### ARCHITECT'S SUPPLEMENTAL INSTRUCTION NO. 6

DATE: March 13, 2024 PROJECT NO: 230117

RE: Streets of West Pryor - Lot 5 Core & Shell

**ROOF PLAN**

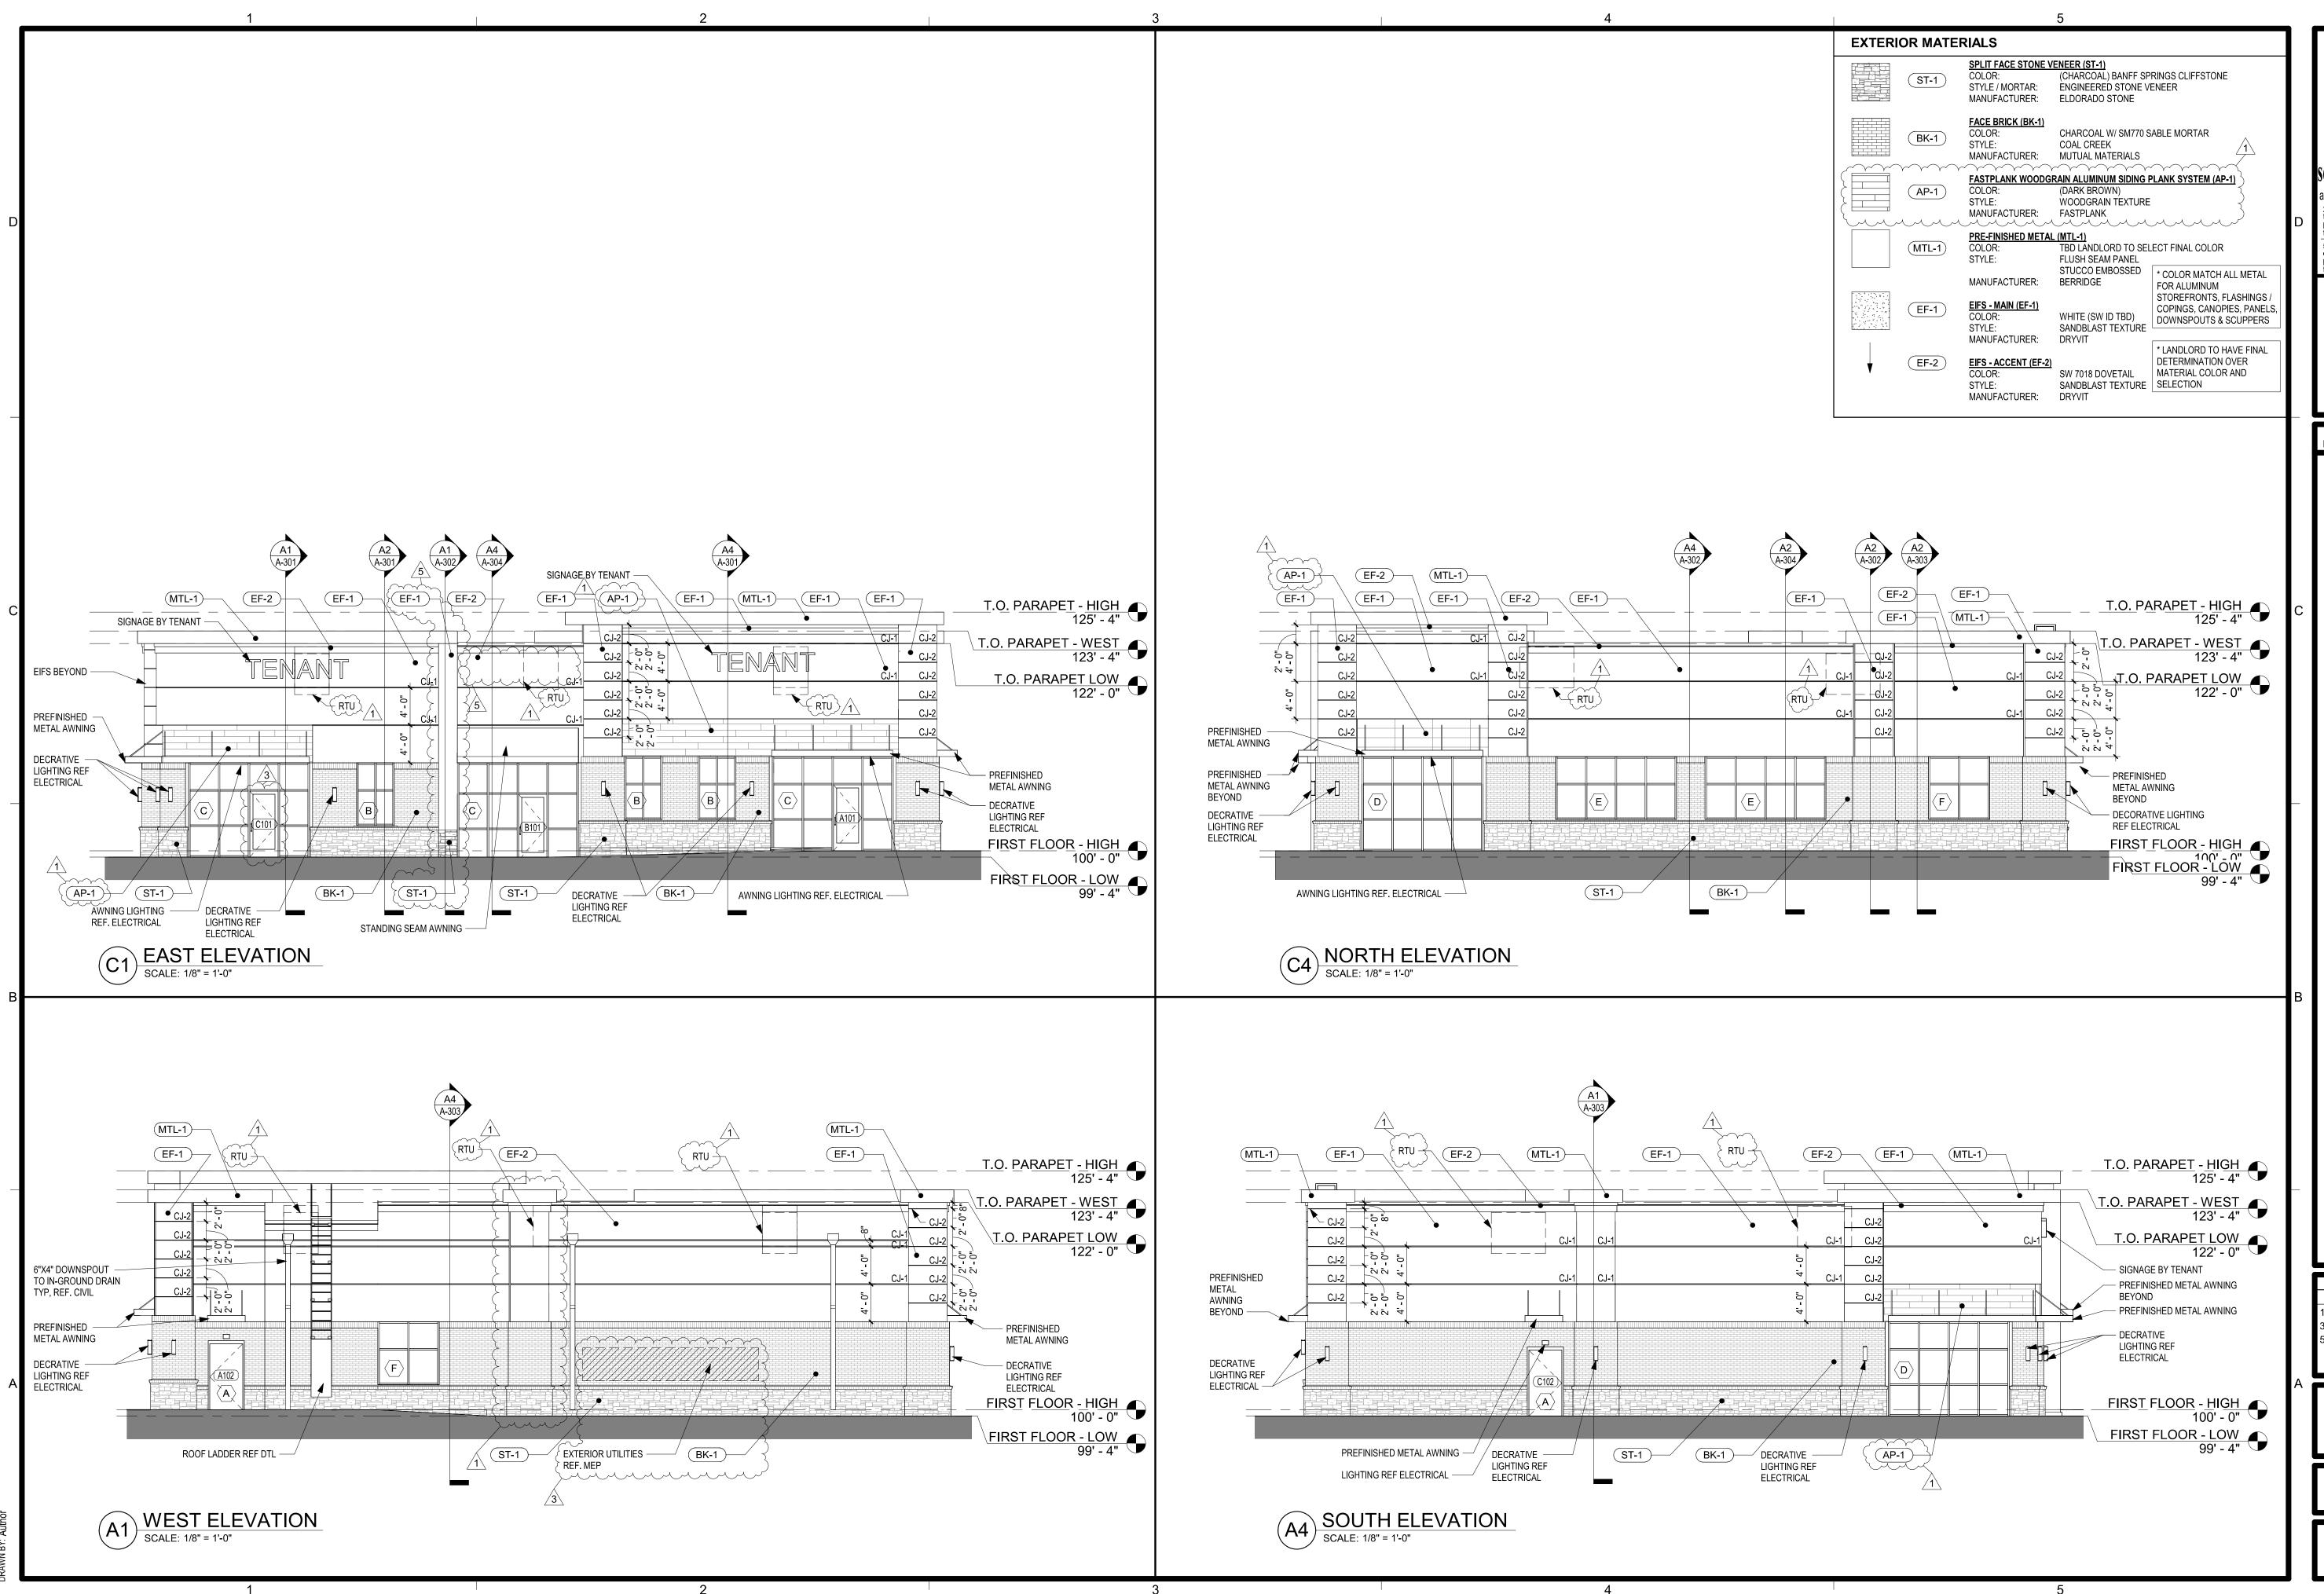
- A-1 Sheet G-001 Code summary updated with usable square foot occupant load calculations and exit requirements for tenant suites A, B & C.
  - A-1.1 Sheet G-001 Code plan updated with occupant load calculations and egress width for tenant suites A, B & C.
- A-2 Sheet A-101 Two hour rated demising wall added to full East to West length of the building spaced 21 feet from face of gypsum board to the other second two hour rated demising wall. Creating and dividing the Core & Shell building into now three separate tenant suites.
  - A-1.A Updating tenant suite designations as Suite A, B & C respectively.
  - A-1.B Updating tenant suite square footage.
- A-3 Sheet A-102 Roof Top Unit added to service enlarged Tenant Suite B space.

SHEET NUMBER
A-201

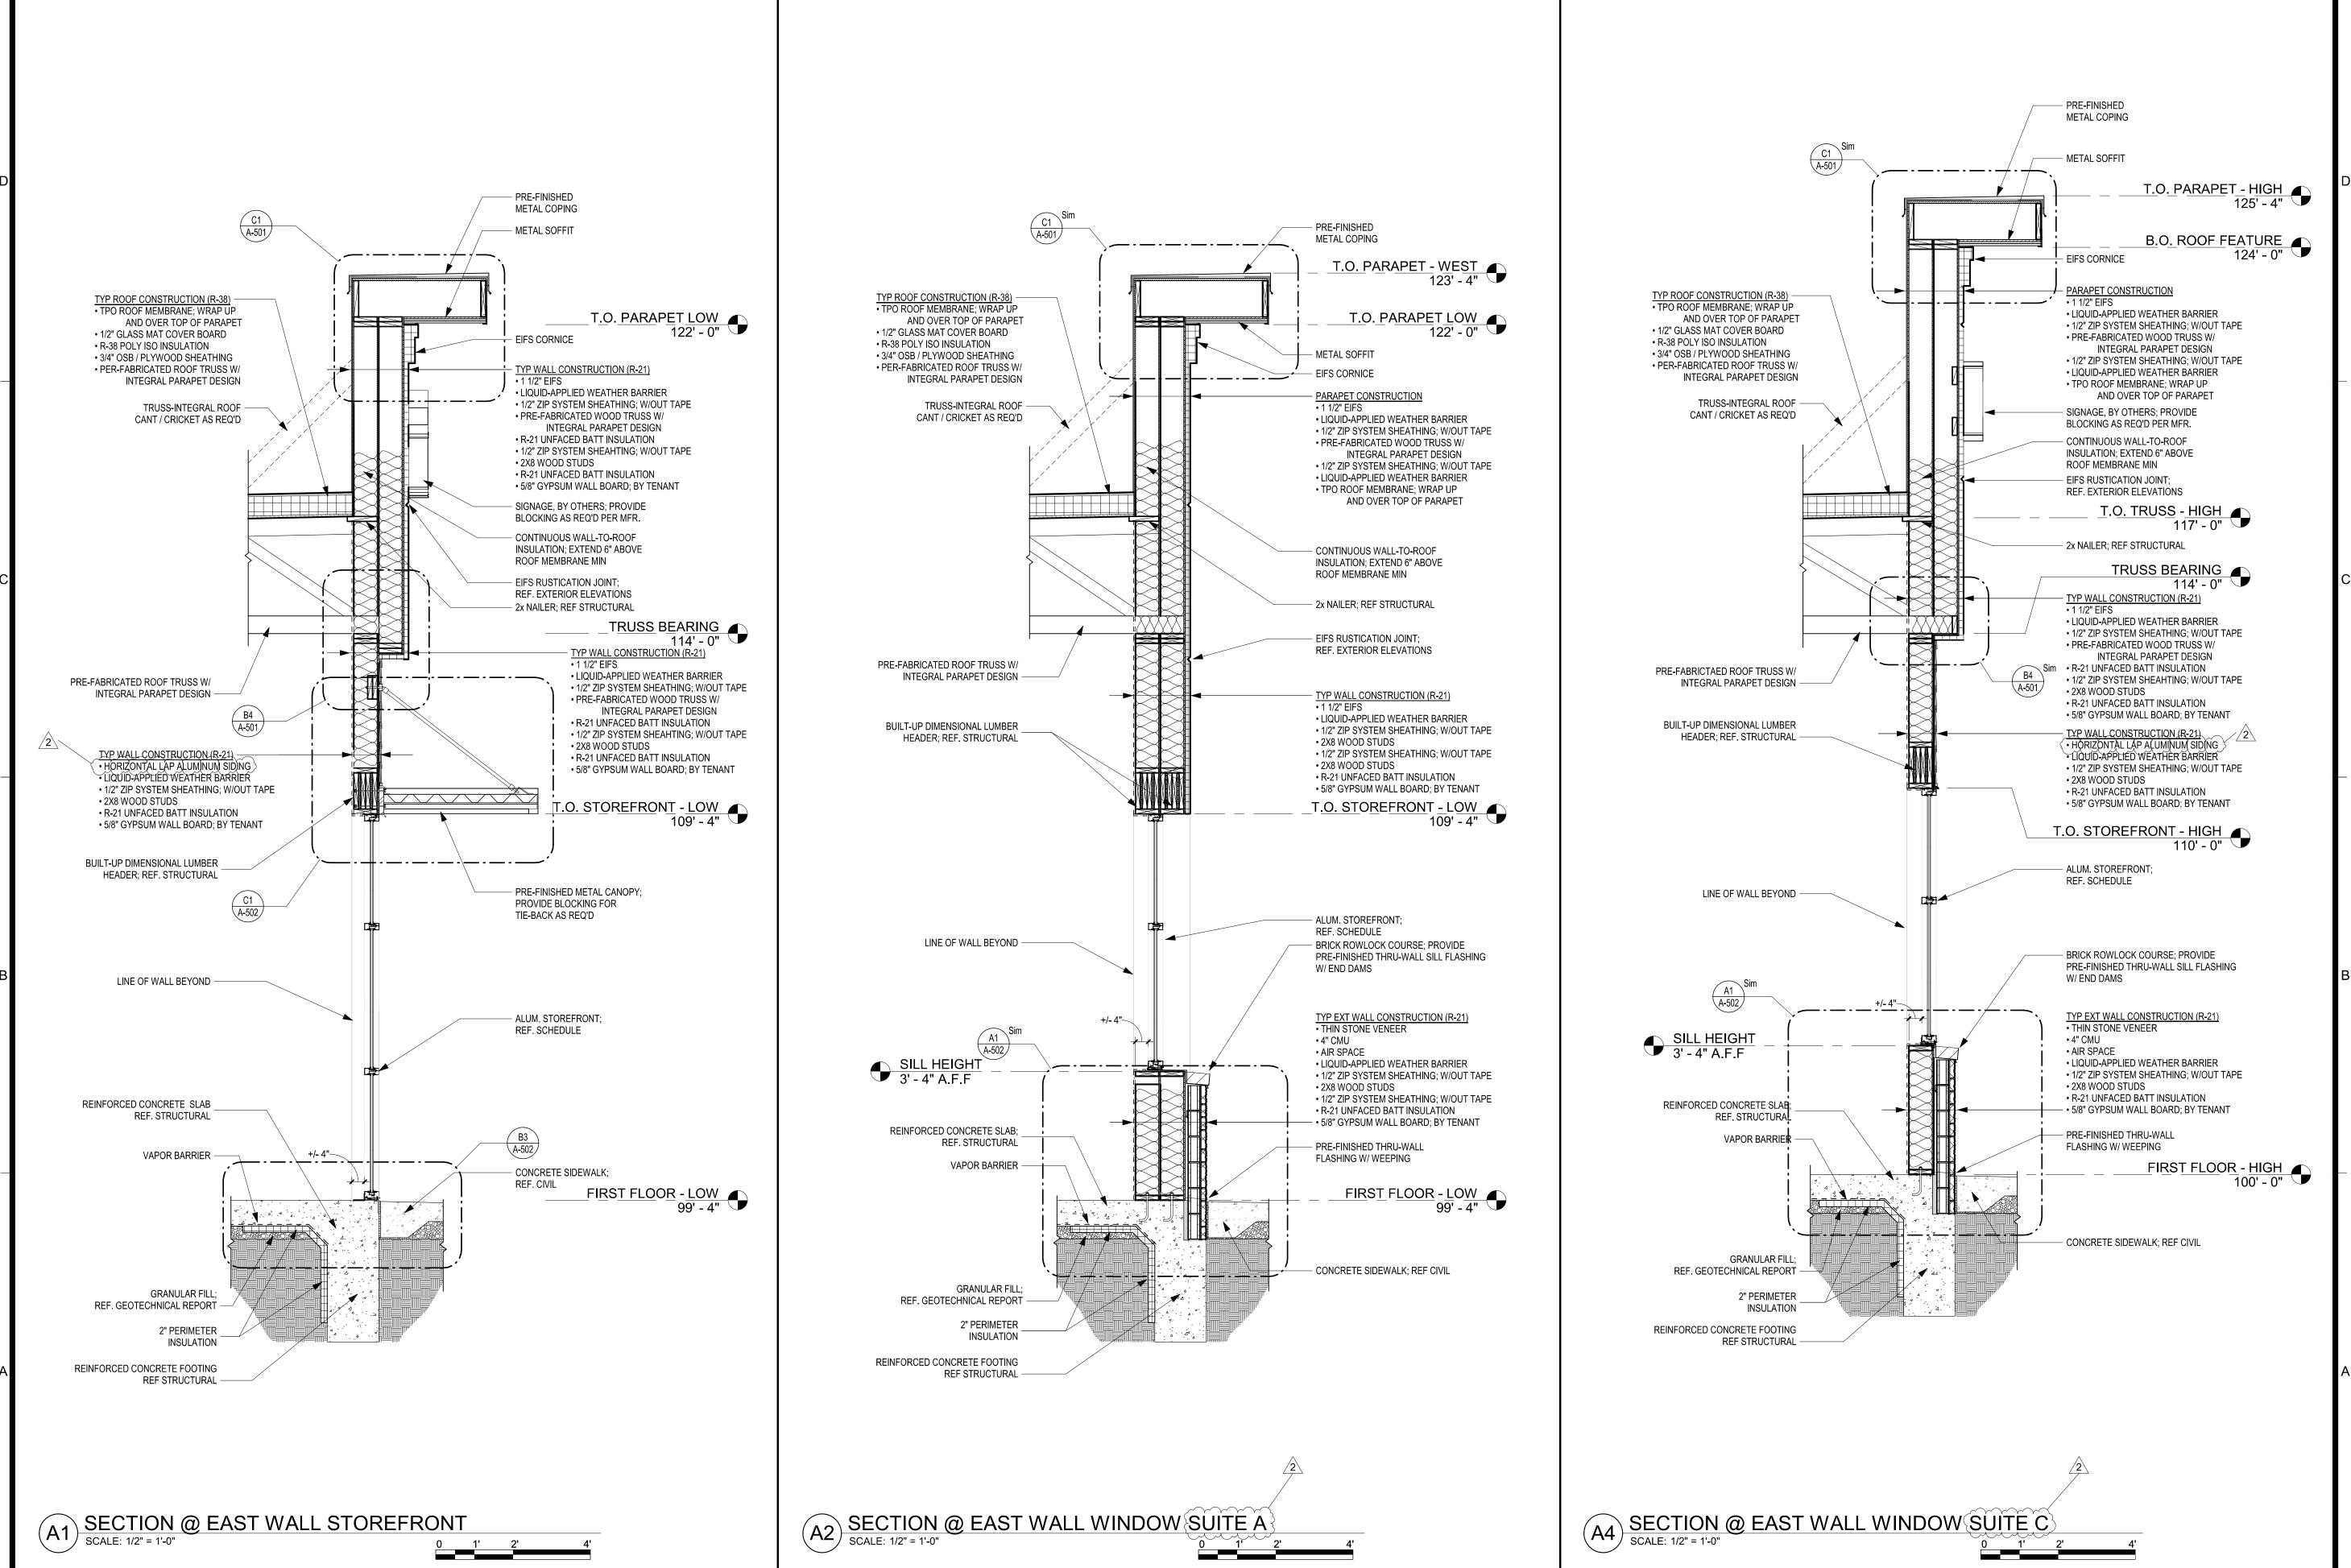
- A-1 Sheet G-001 Drawing A3-Code Plan changed from 3 tenant building to 2 tenant building.
  - A-1.A Drawing A3-Code Plan updated egress load tags.
- A-2 Sheet A-101 Floor changed from 3 tenant building to 2 tenant building. Including removal of fire demising wall, restroom and mechanical room.
  - A-2.A Room tags updated to illustrate proper Suite nomenclature and square footage.
- A-3 Sheet A-201 Drawing C1-East Elevation update illustrating change to Stone wainscot and EIFS 1 at previous brake metal pilaster.
  - A-3.A Drawing C1-East Elevation changed from 3 tenant building to 2 tenant building and tenant signage updated on elevation.
- A-4 Sheet A-401 Removed from scope.
